PLANNING COMMISSION AGENDA

TO: Planning Commission
FROM: Jerry Haddix, Village Administrator
RE: Case 20-08P, Site Plan Review for McDonald's
DATE: April 17, 2020

Staff Report for McDonalds Site Plan

PROPOSED McDONALD'S RESTAURANT AT:
RIVERS CROSSING WEST
VILLAGE OF SOUTH LEBANON, WARREN COUNTY, OH

SHEET: C3.0

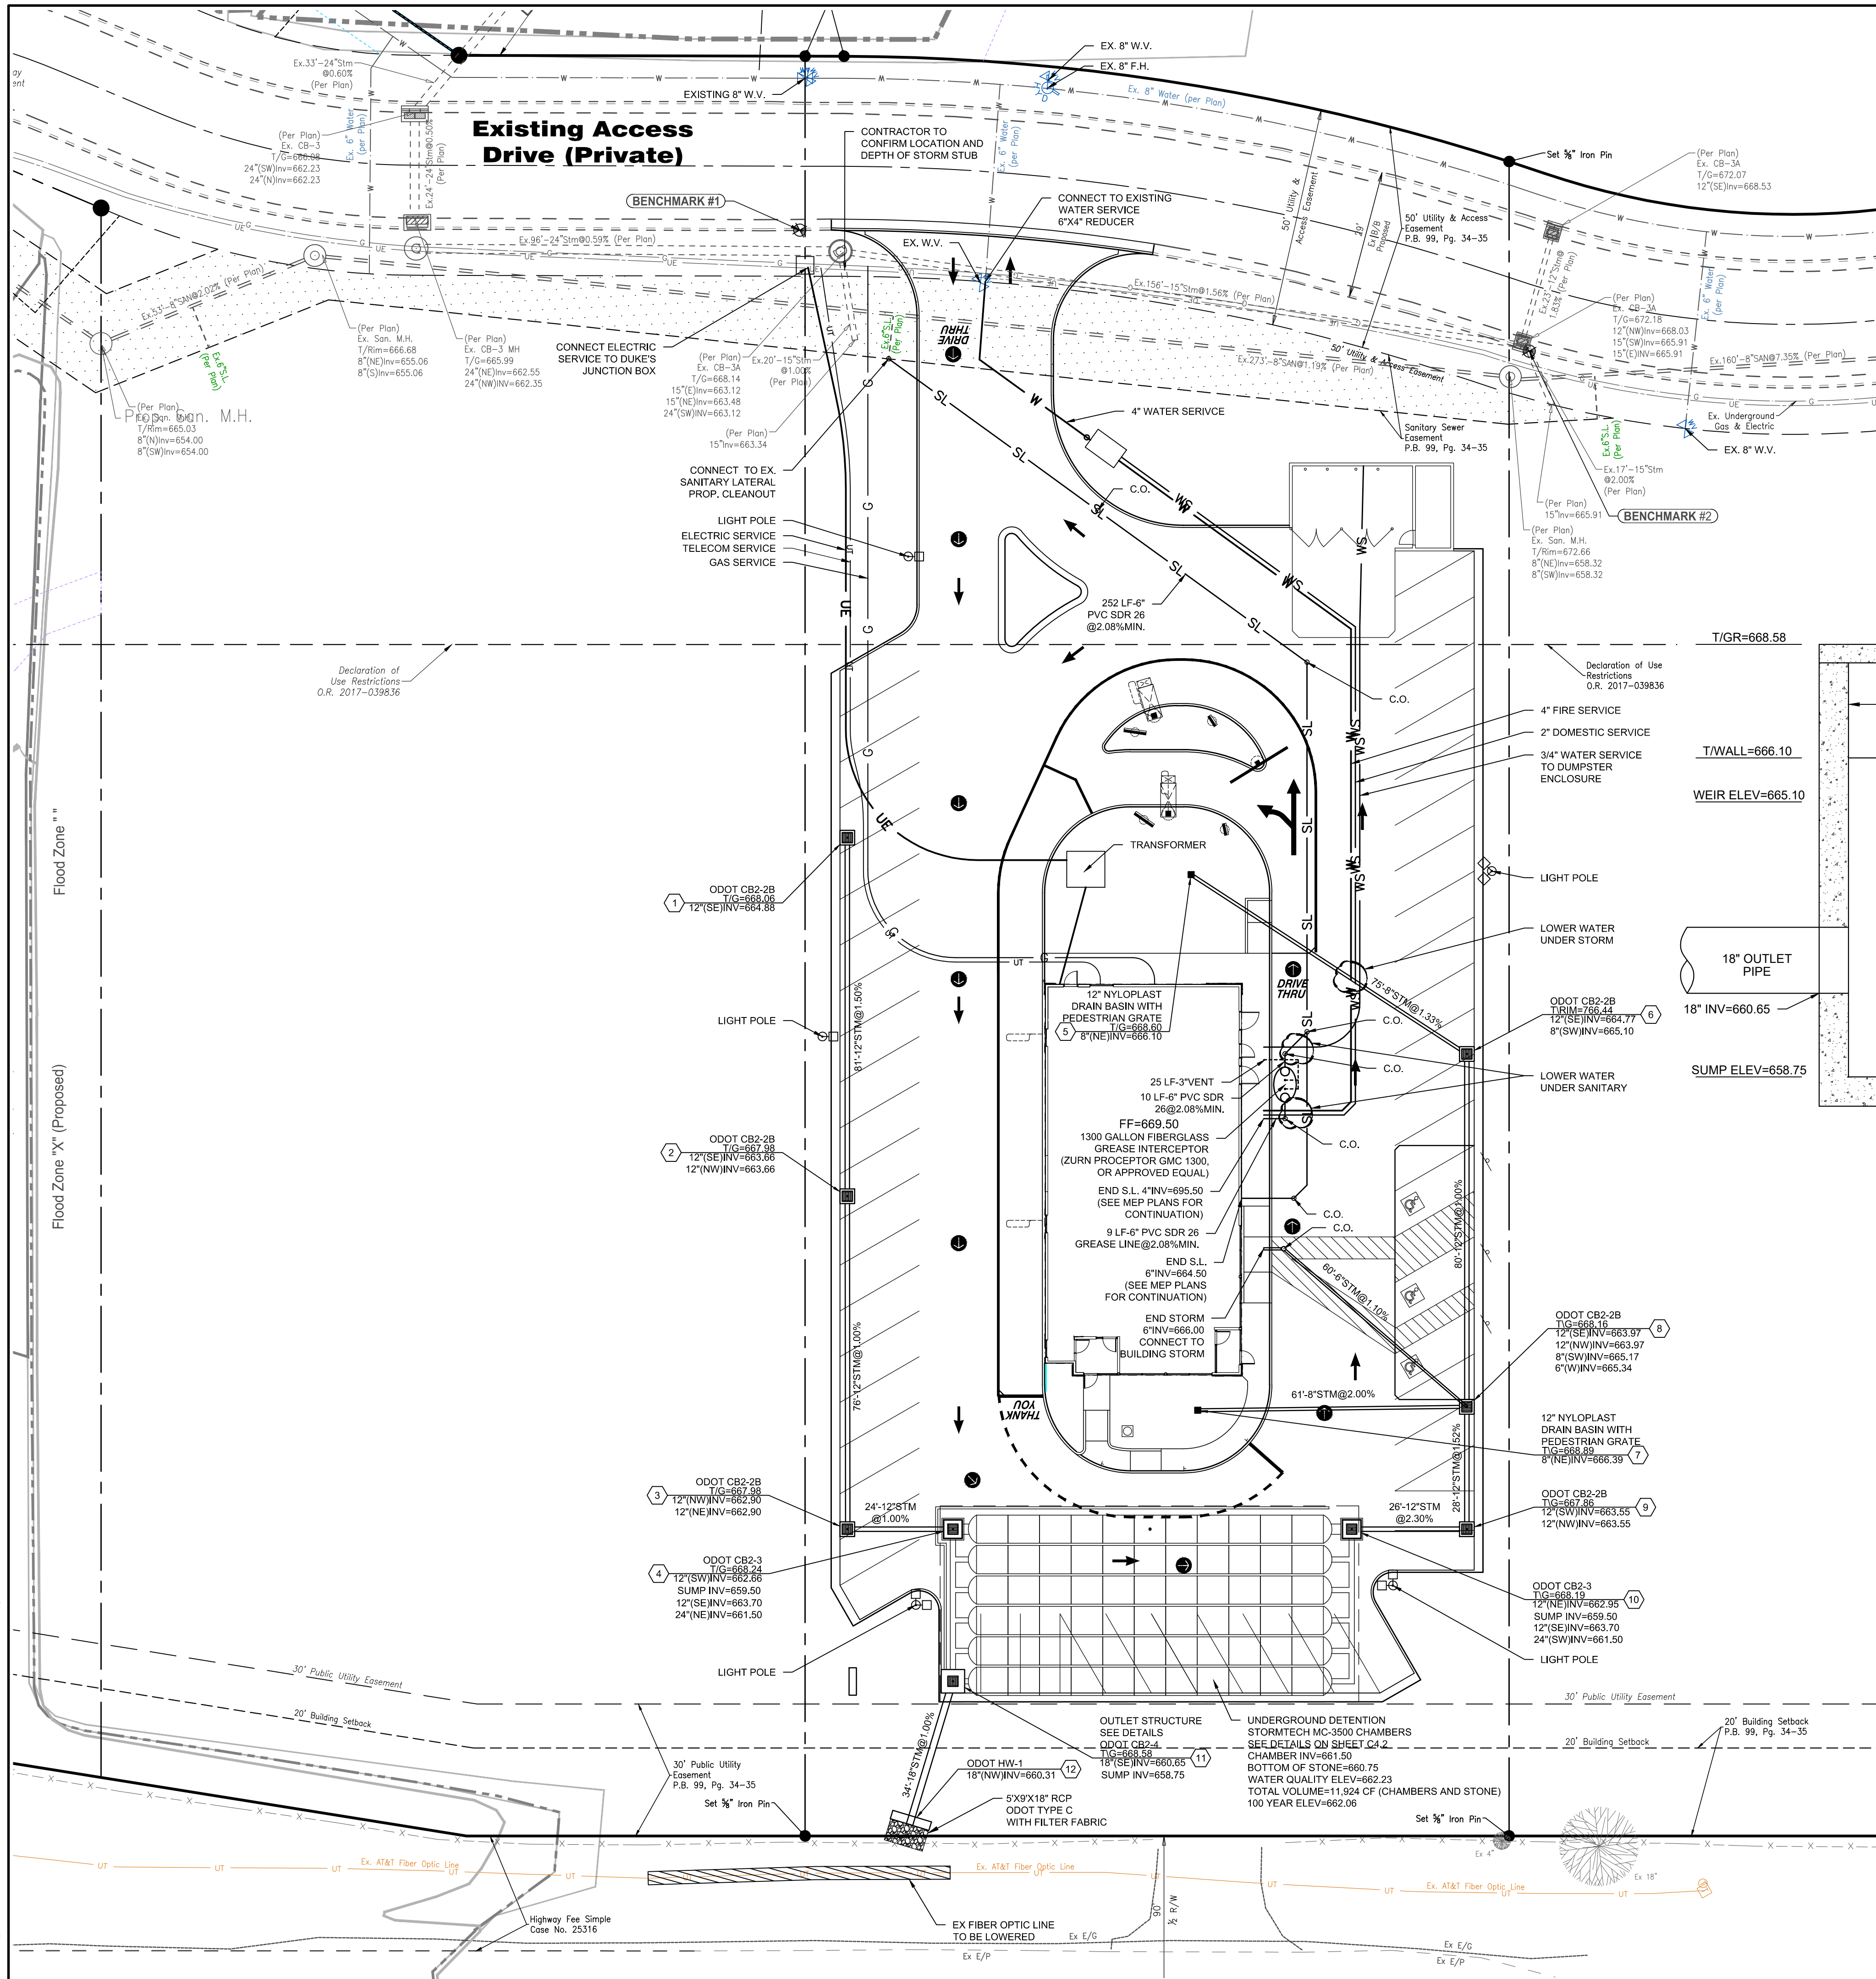
1. Loading space will subtract 8 parking spaces. Clarify when loading space will be in use.

SHEET: C4.0

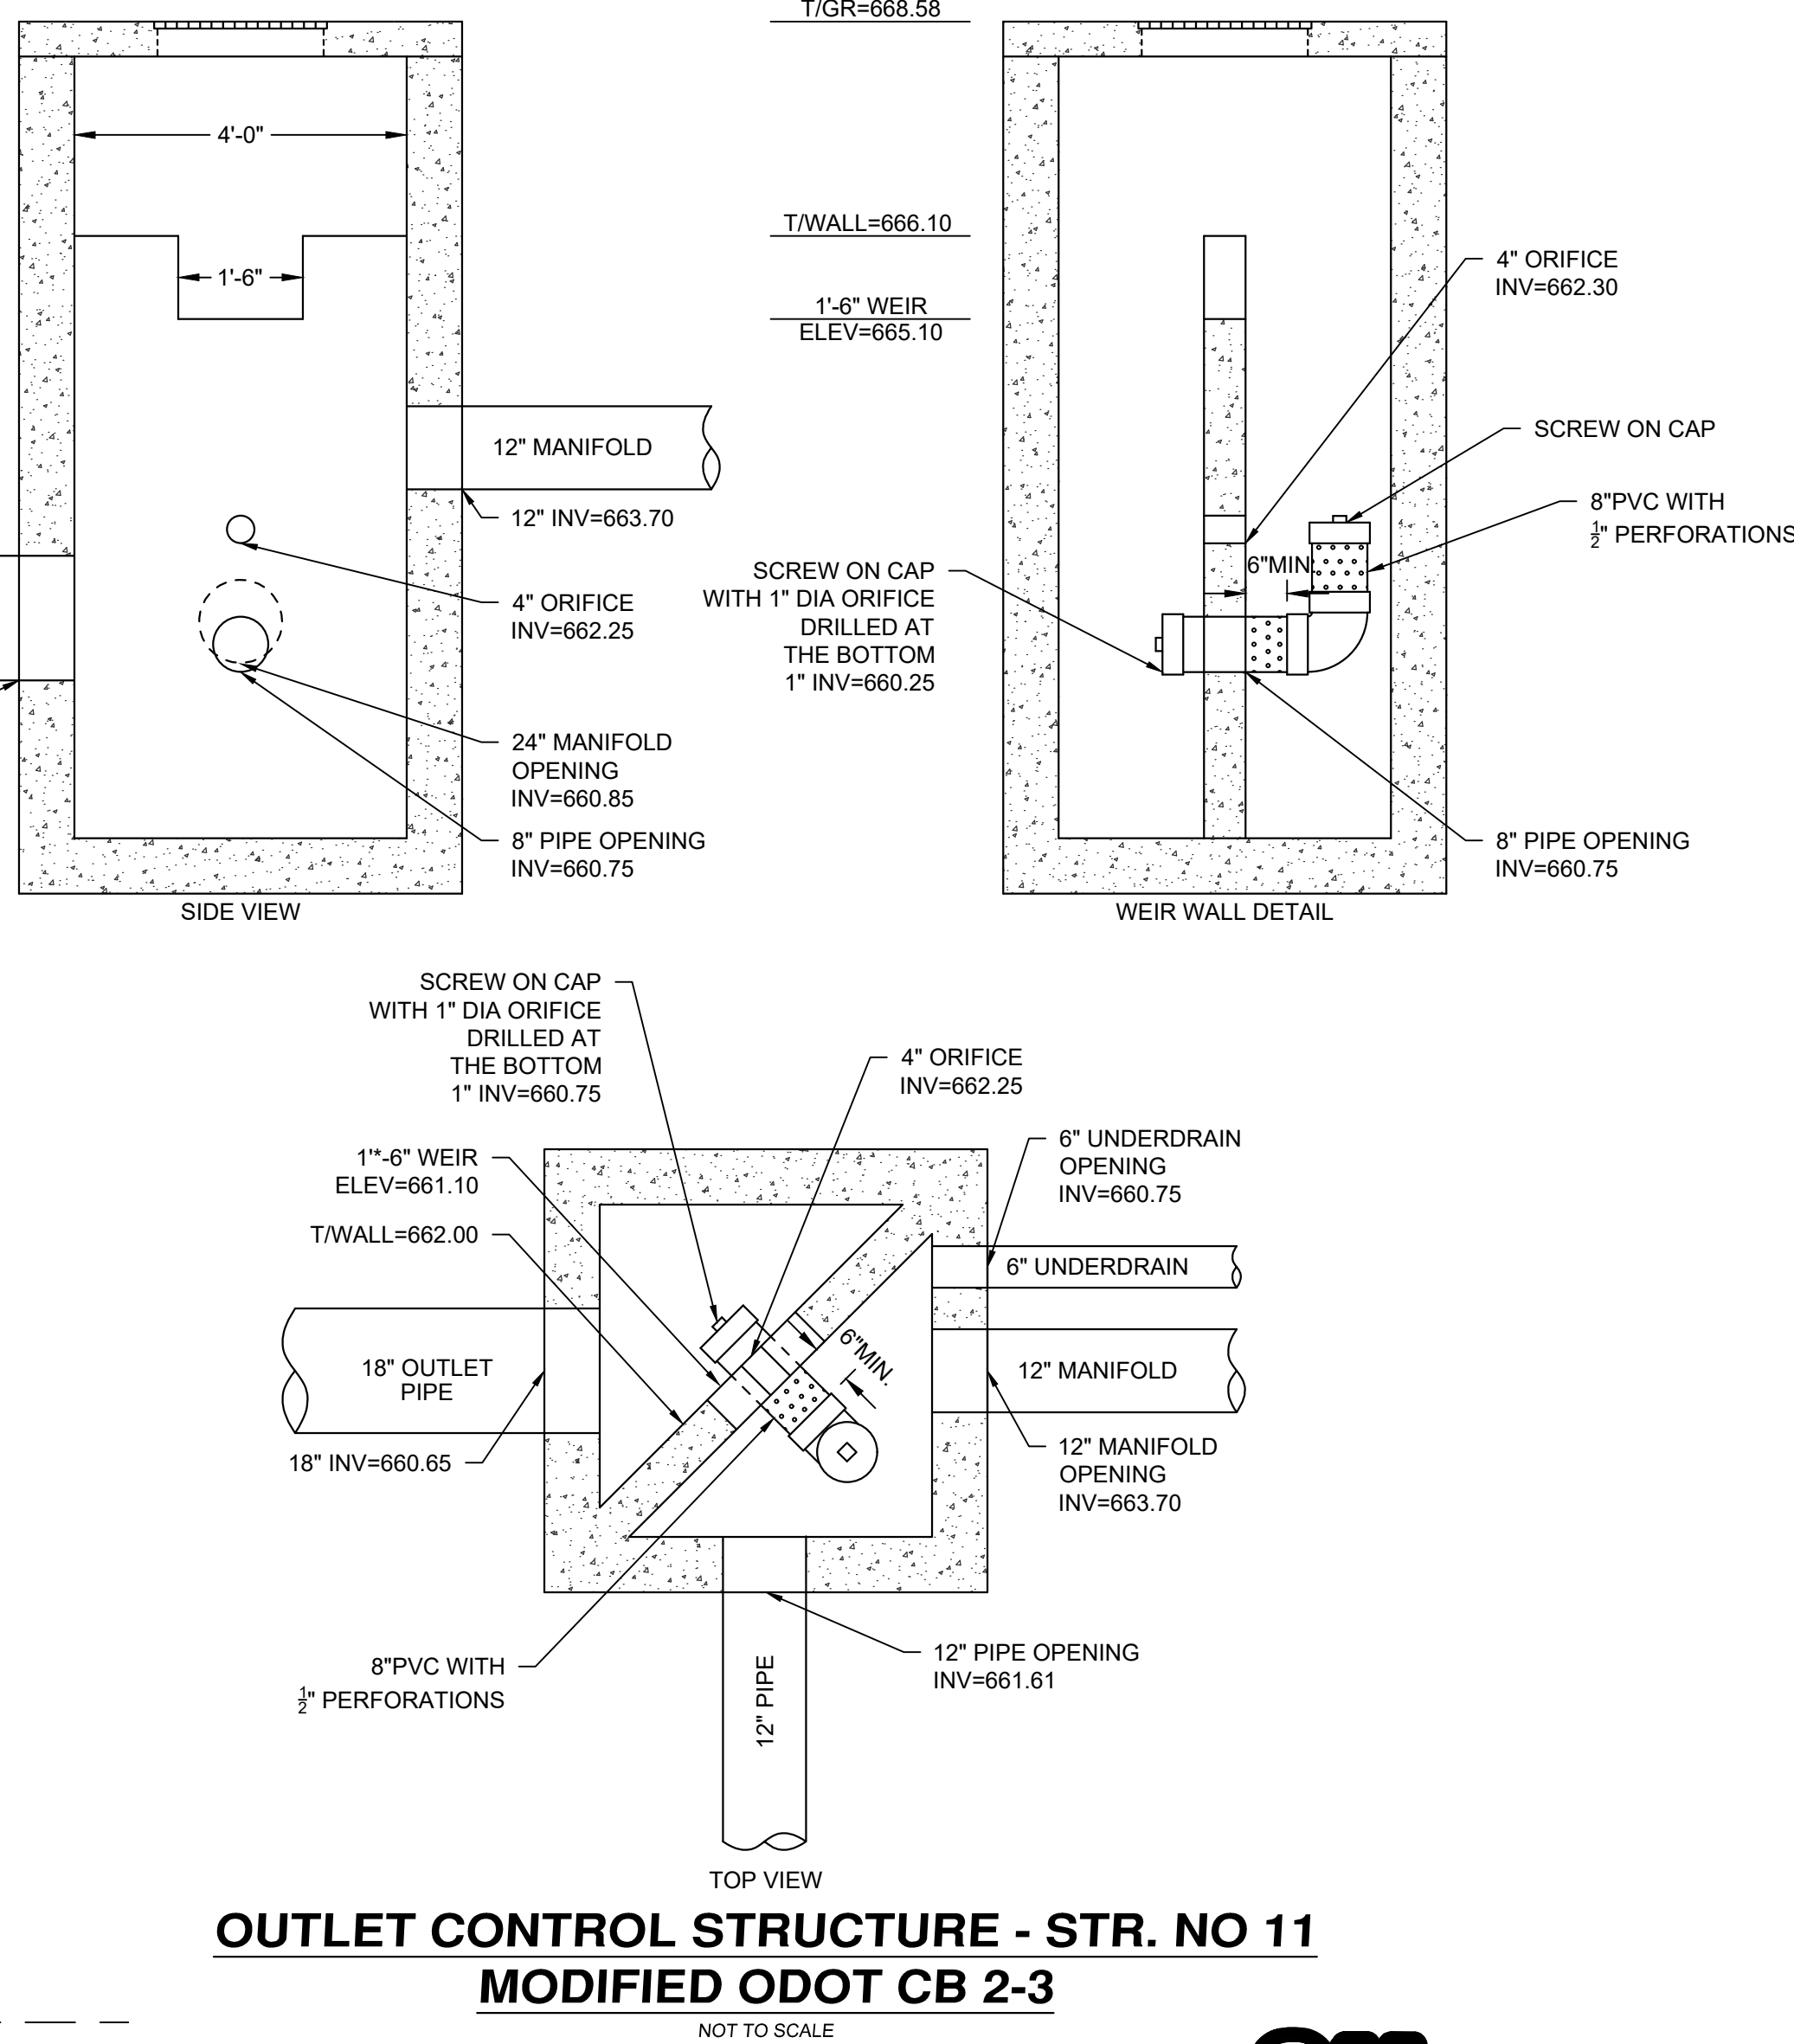
1. It appears there is a typo on the proposed 4" sanitary sewer lateral. 695.50 would put it 26' above the building elevation.
2. Show 100-year overland flood routing on this sheet or on grading plan.

1. Storm pipes are to have a minimum inside diameter of 12" (not including downspout lines). Pipes from structure 5 and 7 need upsized from 8" to 12"
2. UG Detention callout lists 100-yr elevation at 662.06, where it should be 666.06.
3. Has an MR505 been obtained from ODOT for the outlet of the storm system into SR 48 R/W and the grading modifications?

SHEET: C5.0

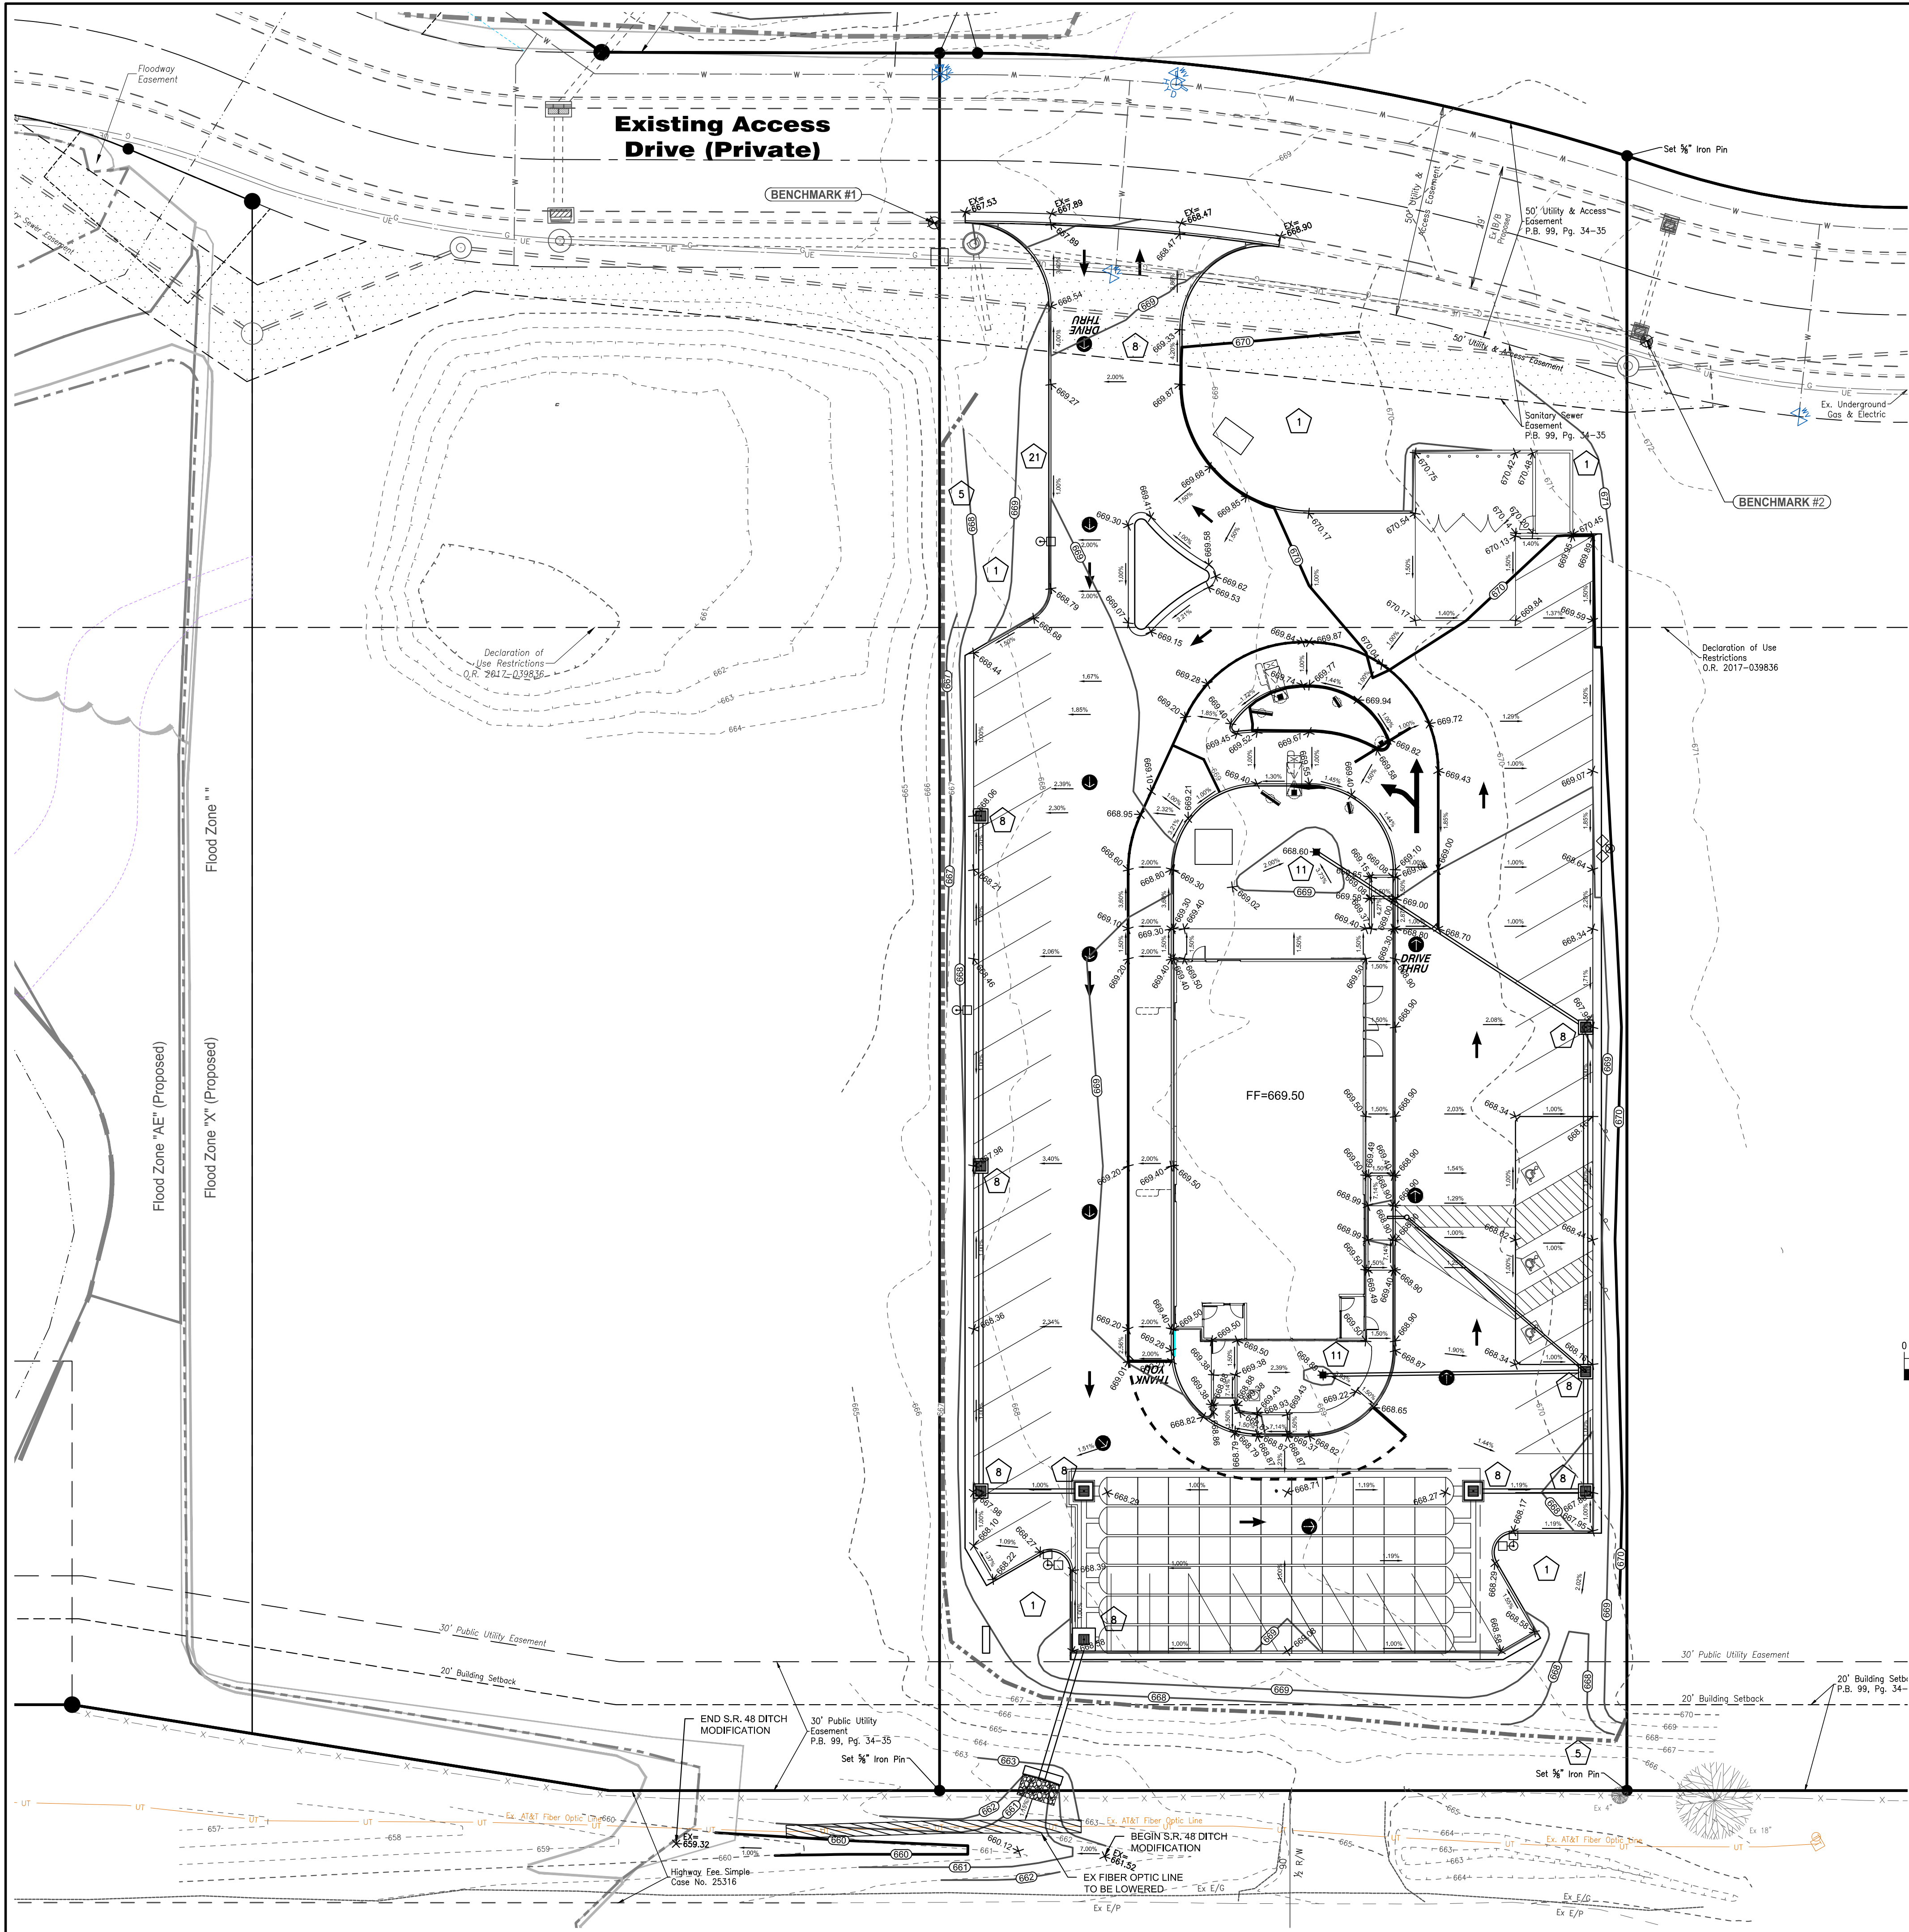
1. Site disturbance is over 1 acre. Provide Village copy of approved NOI.
2. Standalone SWPPP is required. Erosion control notes/details on site plan/grading plan are not acceptable.
